**ADDENDUM  
NO. 1**

**June 5, 2024**

**Connersville High School & Frazee Elem. Renovations  
1100 Spartan Drive – High School  
600 West Third Street – Frazee Elem.  
Connersville, IN 47331**

**Addendum One (AD.01)** to the drawings and specifications prepared by Gibraltar Design for **Frazee Elementary School and Connersville High School Natatorium Renovations** for Fayette County School Corporation, Connersville, Indiana.

**A ED101F**

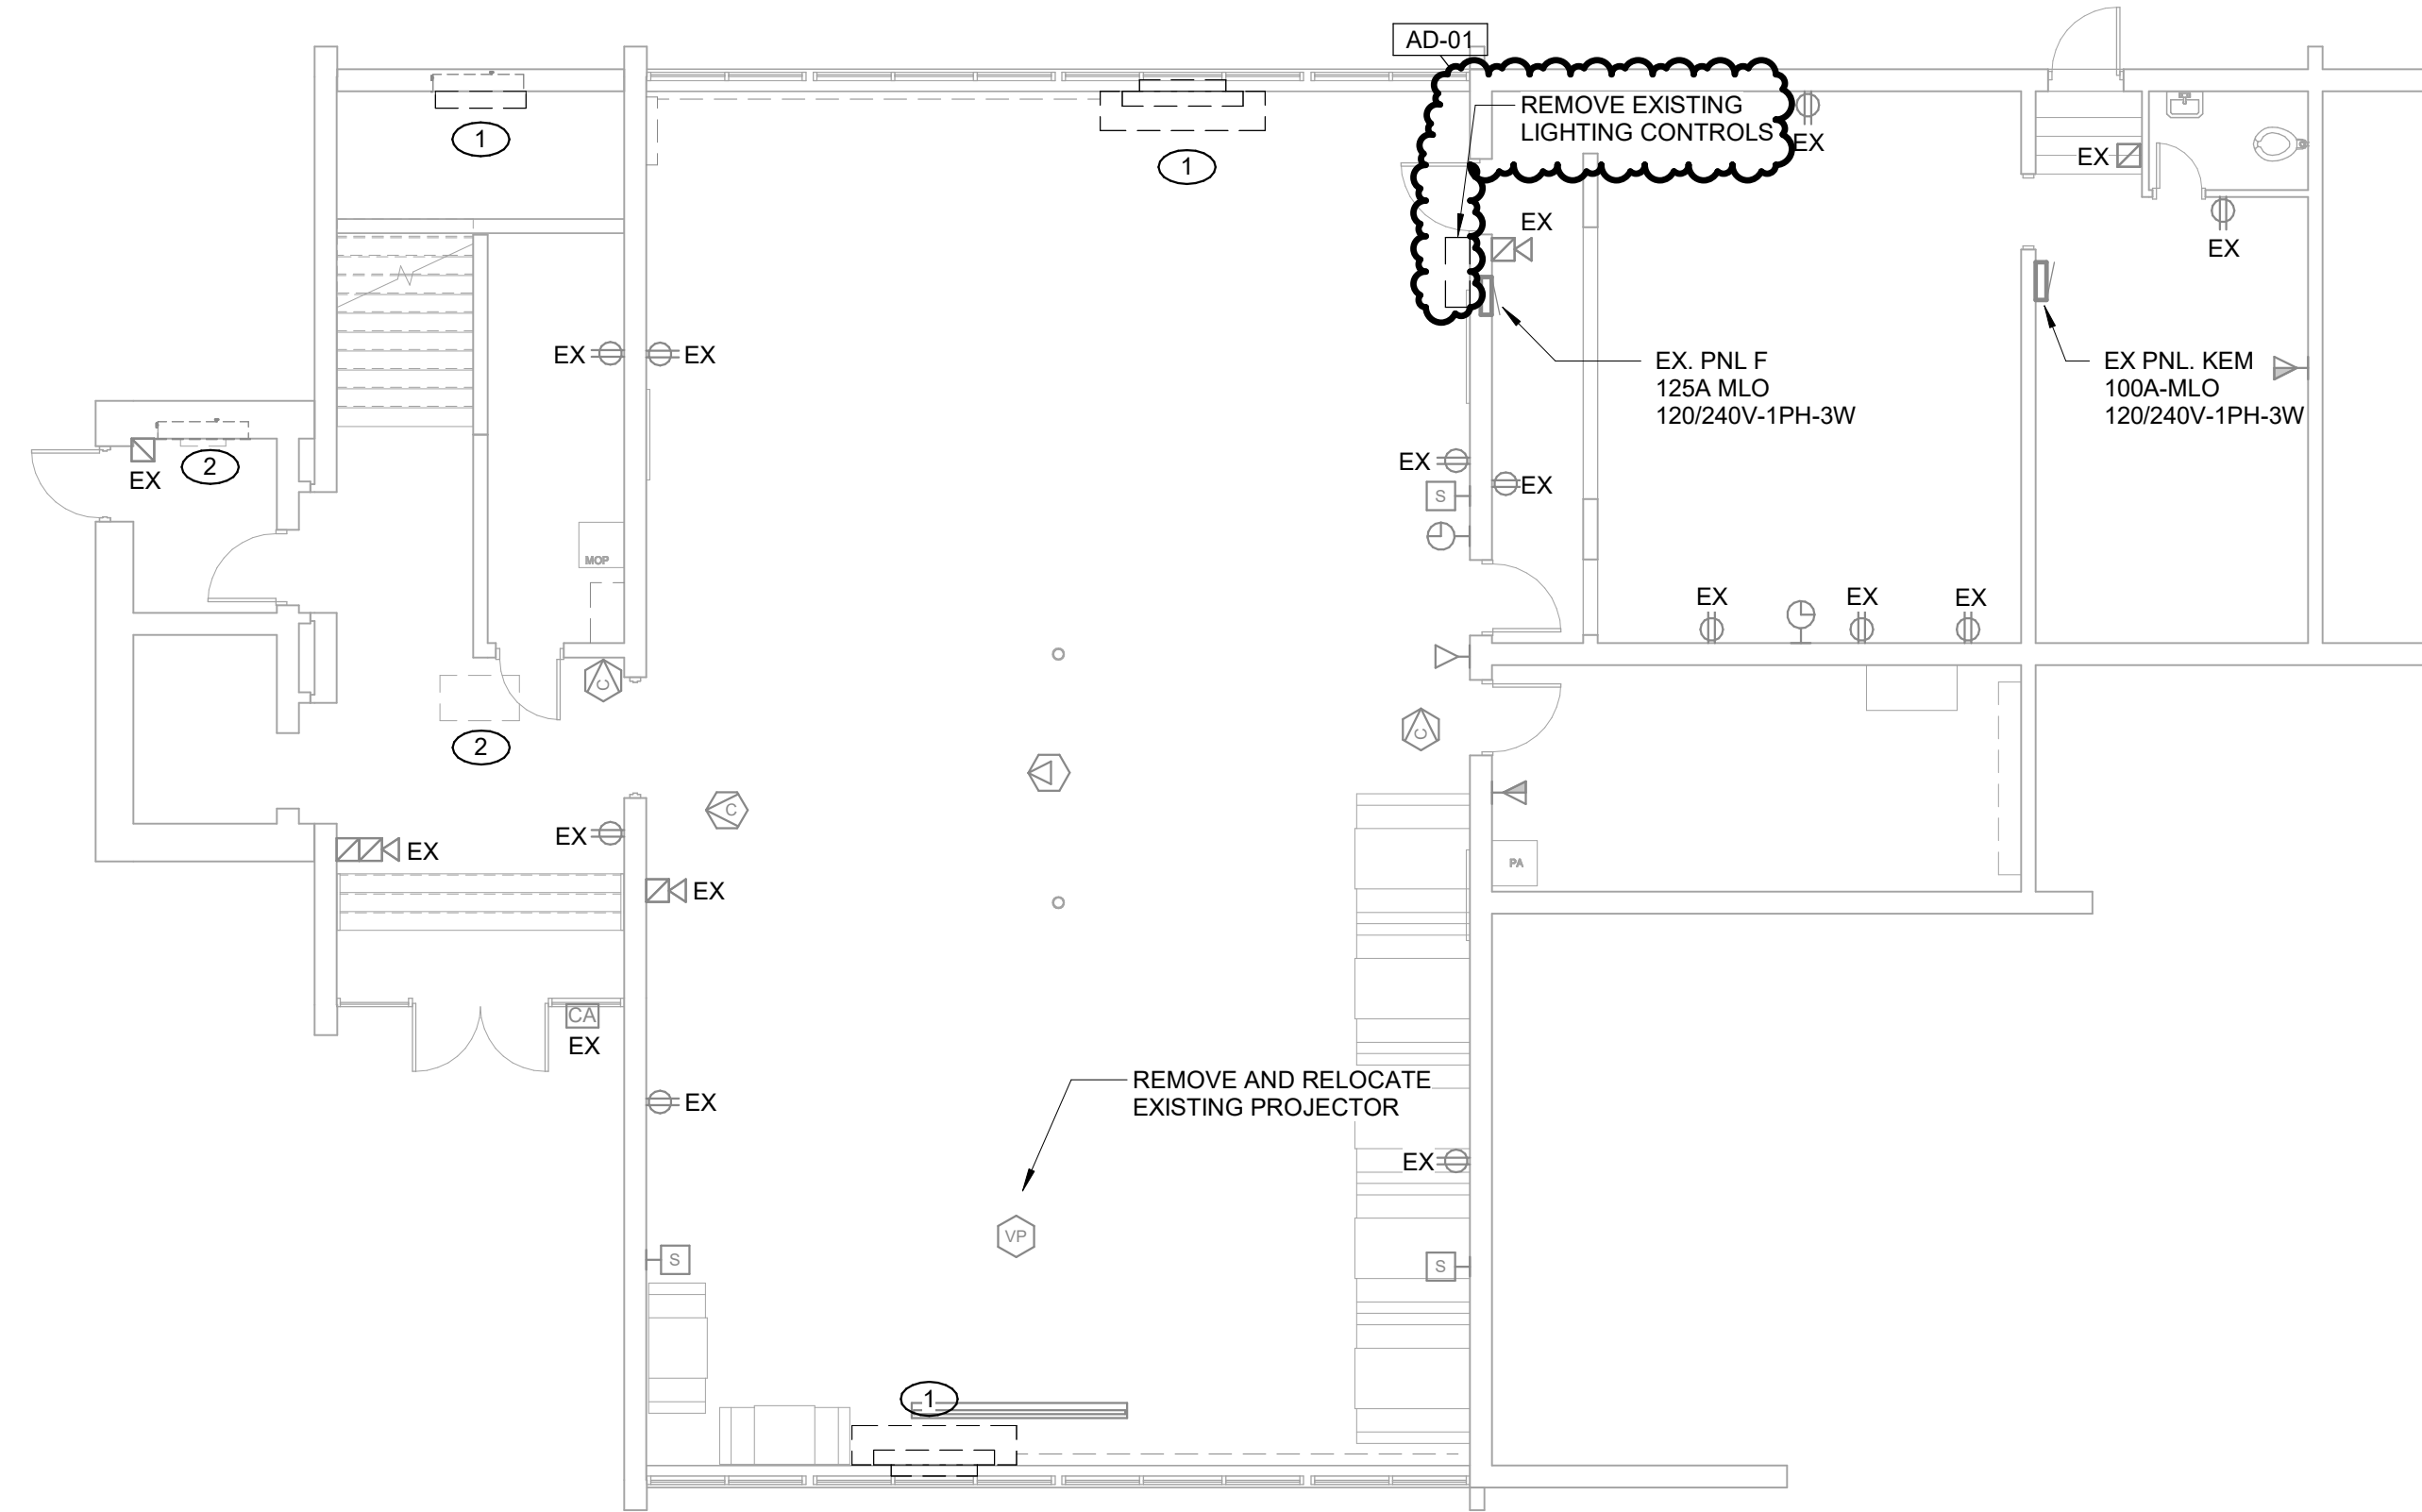
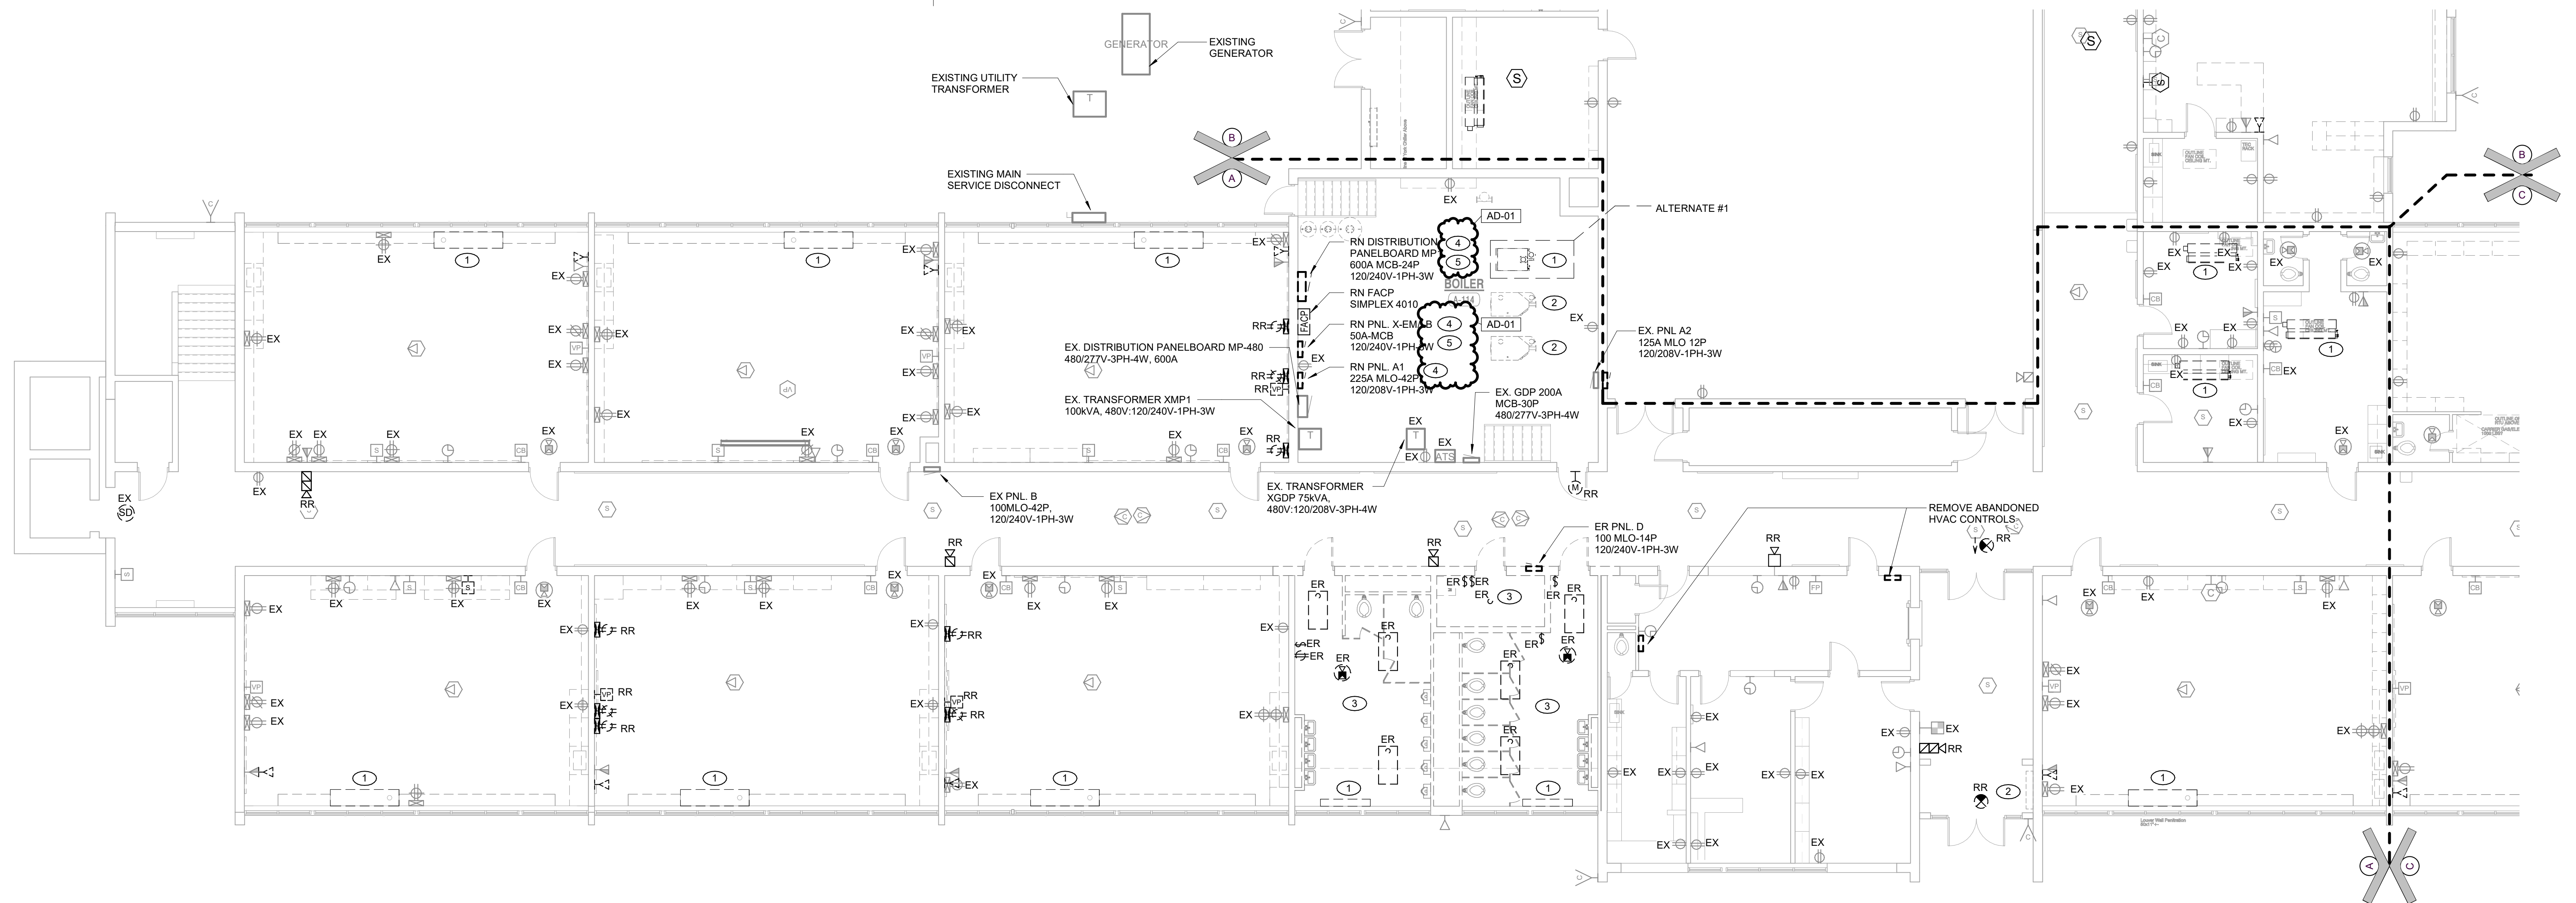
**7. Sheet ED101F**

- A. Refer to revised full size drawing included in this addendum, for the following revision:
1. Existing lighting controls to be demolished in Lighting Lower Level Plan.
